# Parametric test fixture and results for Annex 163B (comment #132)

# comment #132

<i>Cl</i> 163B	<i>SC</i> 163B.2	<i>P</i> 290	<i>L</i> 16	# 132
Ran, Adee		Intel		
<i>Comment Type</i>	<b>TR</b>	<i>Comment Status</i>	<b>D</b>	<i>TP0v/TP5v example</i>
(addressing TBD)				
The example test fixture is defined only by the magnitude of its insertion loss. Therefore it is impossible for a reader to calculate reference values at TP0a, and this example does not help.				
The lack of full channel information also prevents calculation of consensus values to replace the TBDs in Table 163B-1.				
It is suggested to replace the definition to a full s-parameters model based on the equations in 162.11.7.1.1 with the same $z_p$ , creating an IL of 4.33 dB at 26.56 GHz. This will enable calculation of the reference values.				
Alternatively, use a smaller value for $z_p$ to create an IL of 2.8 dB.				
<i>Suggested Remedy</i>				
Replace the text of this paragraph with text referring to 162.11.7.1.1 and equation 162-12 and update the reference values (currently TBD) accordingly.

Table 162–19—PCB model parameters and values

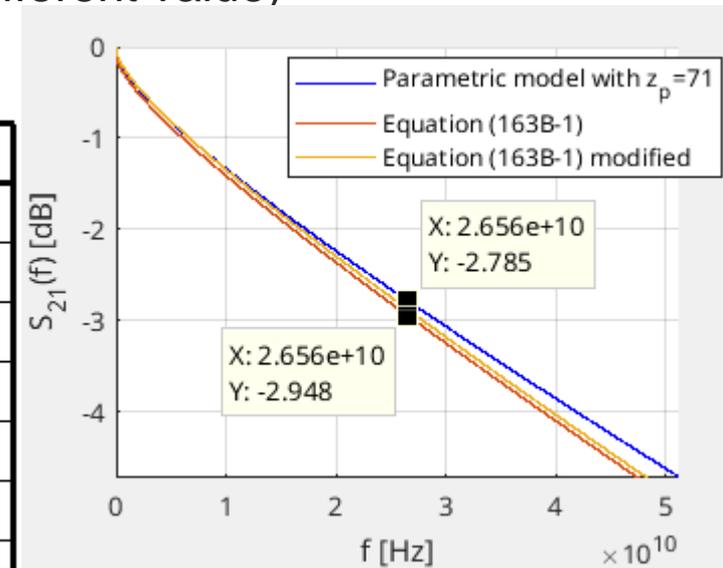
- Using PCB trace model in 162.11.7.1
  - Scattering parameters calculated using Equation (93A–13) and Equation (93A–14) and parameters values given in Table 162–19.
  - $z_p=71$  mm is chosen to achieve  $\sim 2.8$  dB at 26.5625 GHz.  
(Equation 163B-1 actually yields a slightly different value)

This example test fixture is defined using the PCB trace model in 162.11.7.1, with  $z_p=71$  mm, and parameter values in Table 162–19, with the exception that  $C_0$  and  $C_1$  are both 0. This results in a TP0-TP0a insertion loss of 2.8 dB at 26.5625 GHz.

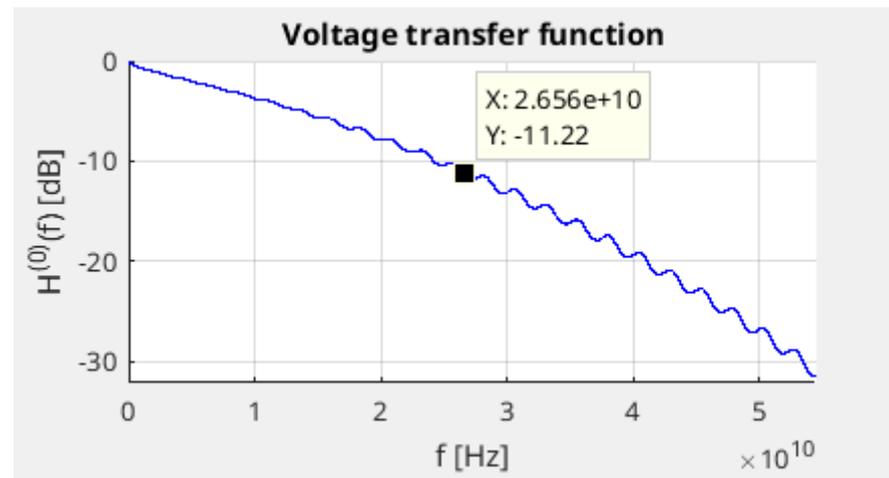
Apparently, there is a mistake here;  $H_{BT}$  should use 40 GHz rather than  $f_r$  - but in this case the difference is insignificant

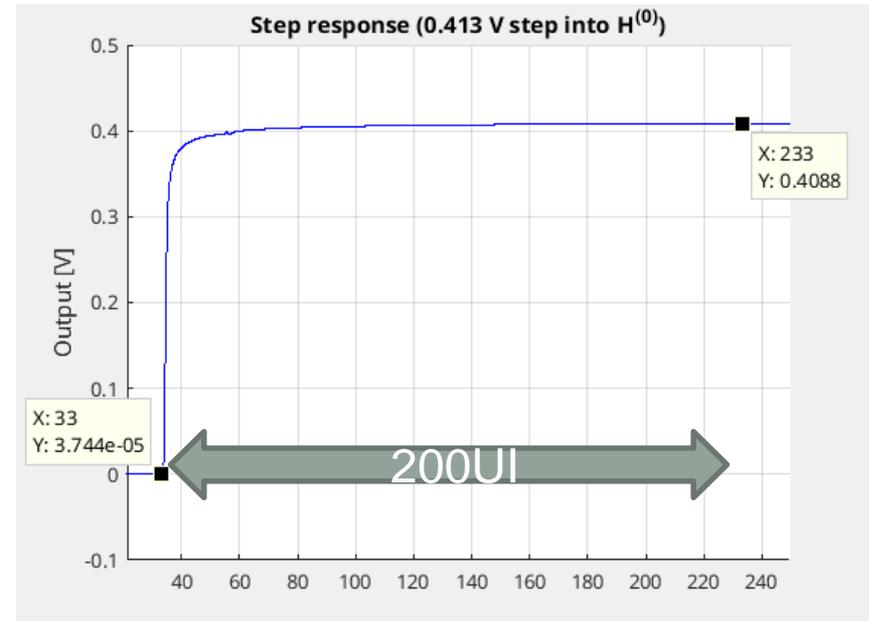
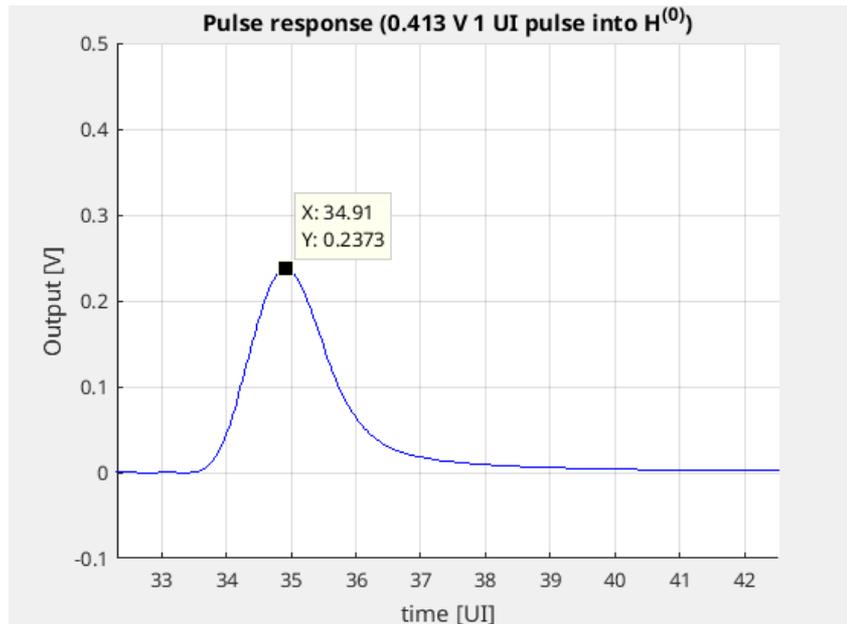
Should be  $A_v$

The reference values are calculated for the transmitter characteristics of Clause 163. The reference transmitter device and package model uses the parameter values  $T_r=7.5$  ps,  $f_r=0.75 \times f_b=39.8438$  GHz,  $z_p=31$  mm, and  $A_v=0.413$  V. The values of  $v_{peak}$  and  $v_f$  are calculated with  $f_b=53.125$  GBd and  $N_v=200$ .
